**City of Portland, Maine – Building or Use Permit Application** 389 Congress Street, 04101, Tel: (207) 874-8703, FAX: 874-8716

BUILDING PERMIT REPORT

REASON FOR PERMIT: To Amend permit No. #001330.

## COMMENTS ON LOT #12 FROM 11-1-00 STAFF MEETING

Figure No.  
 1

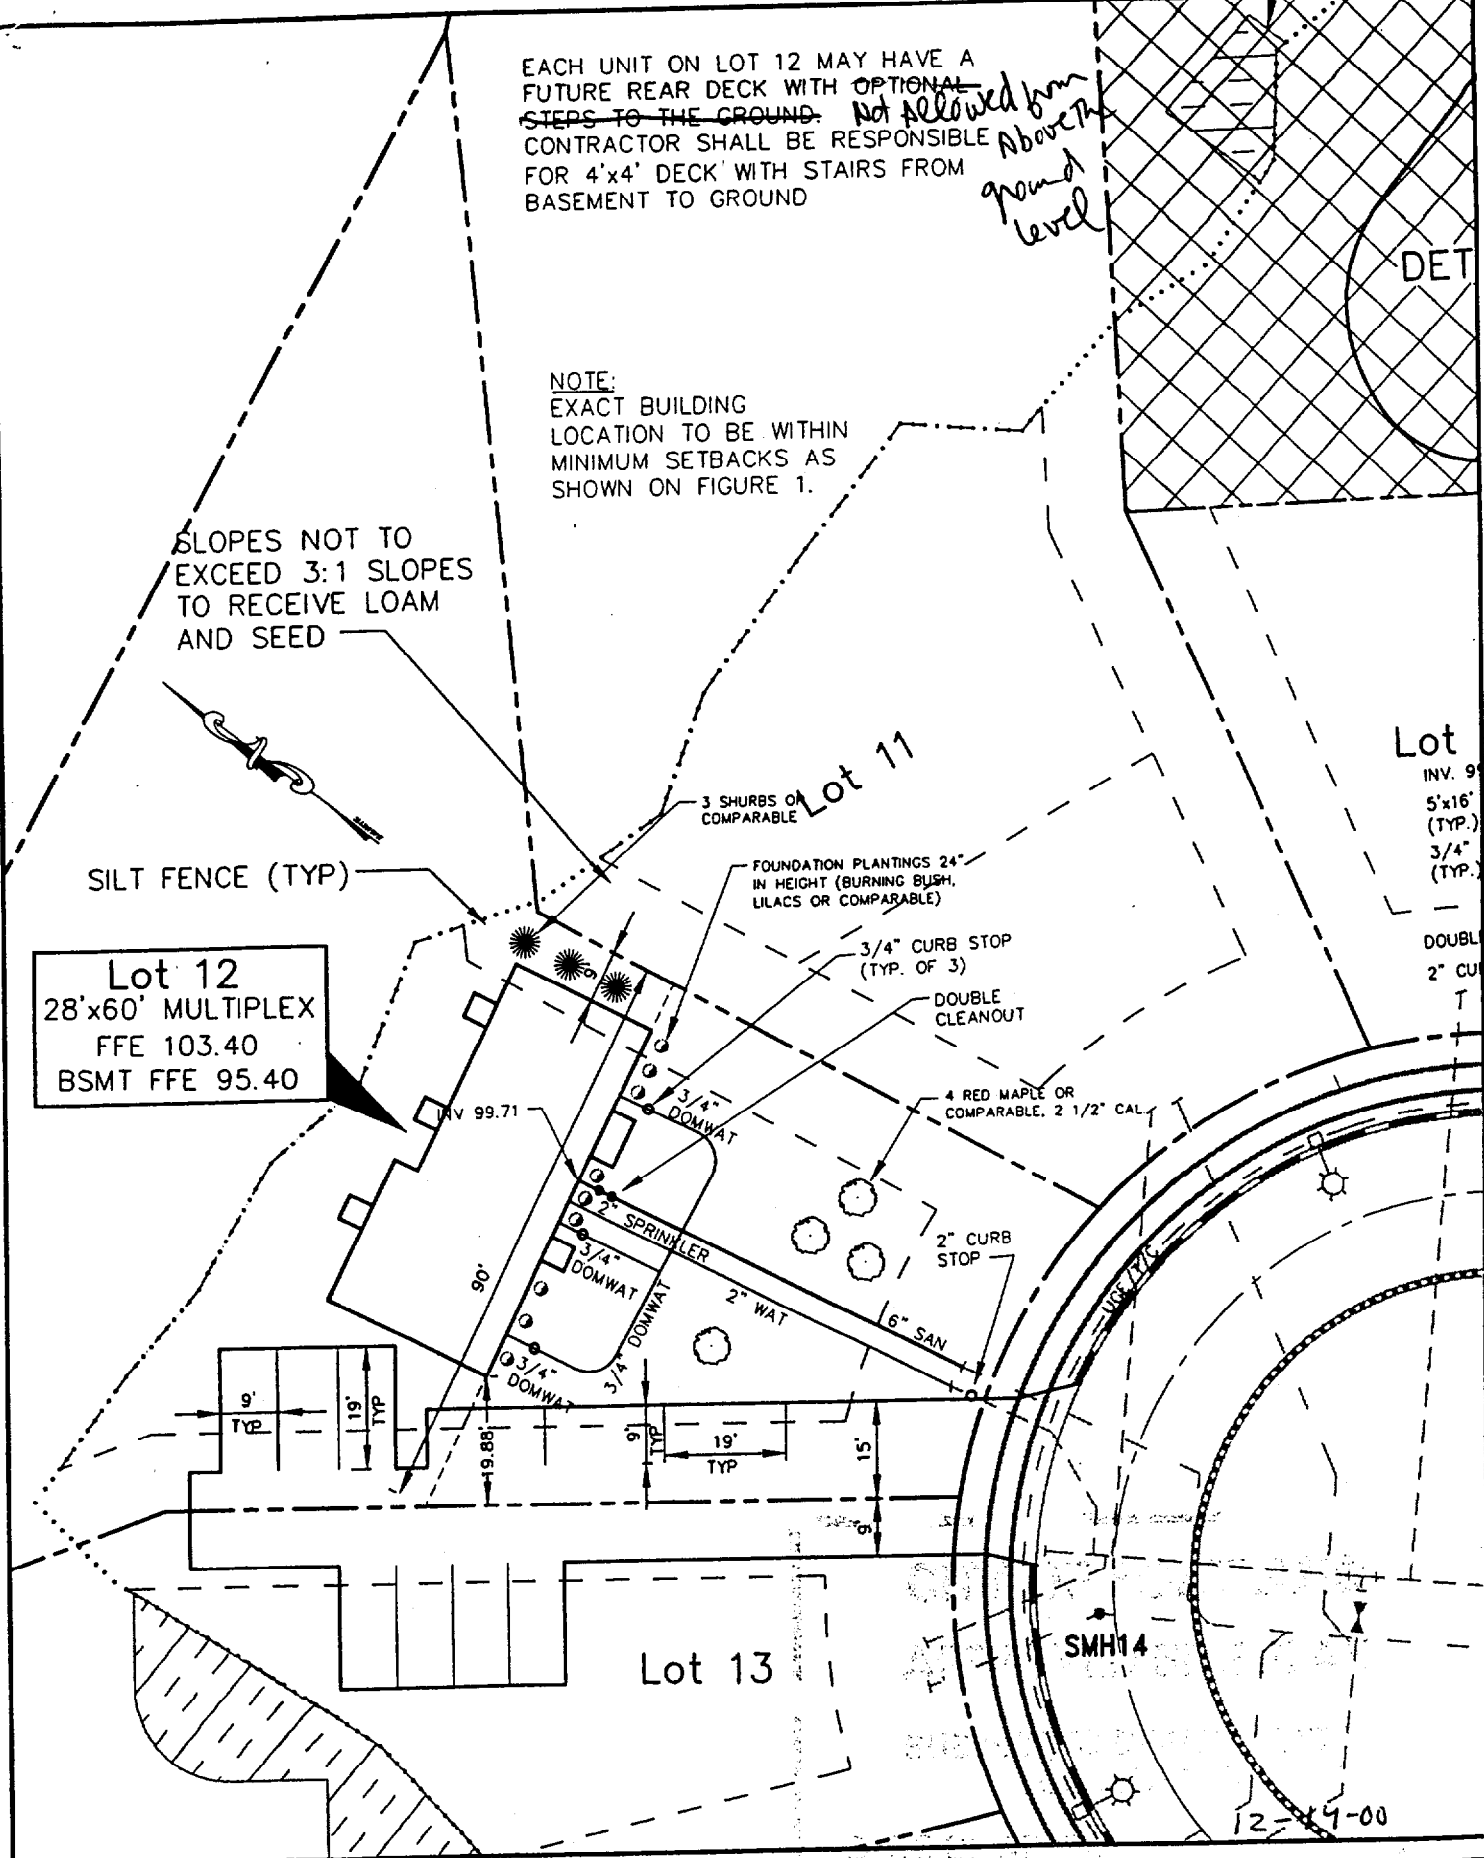
EACH UNIT ON LOT 12 MAY HAVE A FUTURE REAR DECK WITH OPTIONAL STEPS TO THE GROUND. *Not allowed from ground level*  
 CONTRACTOR SHALL BE RESPONSIBLE FOR 4'x4' DECK WITH STAIRS FROM BASEMENT TO GROUND

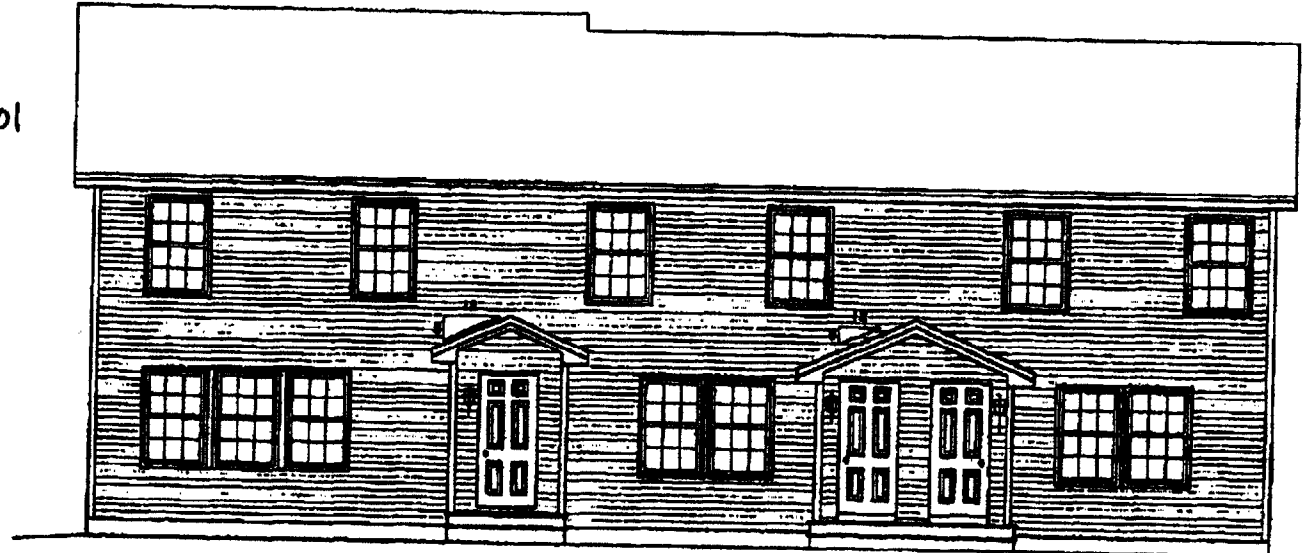
1. SITE PLAN SHOULD SHOW THE DECK FOOTPRINTS AND BACK STAIRWAYS. THERE IS A SIGNIFICANT 5 FOOT DROP FROM THE FLOOR TO THE GROUND. STAIRS ARE A CODE REQUIREMENT.

2. SUBMIT SPECIFIC SLOPE STABILIZATION MEASURES ON THE PLAN. ONE OPTION IS TO MAKE IT LESS STEEP. WE WILL NOT ACCEPT MORE THAN A 3 TO 1 SLOPE.
3. INDICATE INSTALLATION OF A SILT FENCE UPGRADG FROM THE WETLAND PRION TO CONSTRUCTION.

5. AN EXTRA WINDOW ON THE 2ND FLOOR (RIGHT ELEVATION) NEEDS TO BE ADDED. THIS ELEVATION HAS ONLY 2 WINDOWS, WE SEE NO COMPELLING REASON WHY A WINDOW SHOULD NOT BE THERE.

6. THIS IS A BIG BUILDING. NEED 9 FOUNDATION BUSHES ALONG THE FRONT FOUNDATION, ALSO AN ADDITIONAL DECIDUW TREE NEEDS TO BE PLANTED IN THE FRONTYARD BETWEEN THE DRIVEWAY AND ONSITE WALKWAY.

1. The decks and stairs *Not Allowed* have been added to the site plan.
2. Gorrill-Palmer & Steve Bushy from Deluca - Hoffman, both agree that RipRap is an acceptable slope stabilization measure. There is no way to get a 3 to 1 slope with a 12' drop over 24'. Both the Buyers for lots 11 & 12 do not want retaining walls between buildings for liability and maintenance reasons. If we bring the slopes out past the front of the Buildings the sides would have to become a daylight basement, this would effect our building envelope, grading and final appearance that the purchasers are looking for. We have been patient with this process but we feel it is putting extra burden and is unreasonable to force the purchasers into something they do not want.

3. The silt fence is in place, but we will add it to the site plan.
4. The set back issues have been addressed with Marge at my meeting with her last week. There is a 12' setback because less then  $\frac{1}{2}$  of the building is daylight walls, if more then  $\frac{1}{2}$  was daylight then it would have been 2.5 stories.

5. We will ad an extra window per your request. This will be done in the field and can be part of your C. O. Approval.
6. Extra bushes will be added, we have already escrowed \$2,000 with the city for final site work completion.
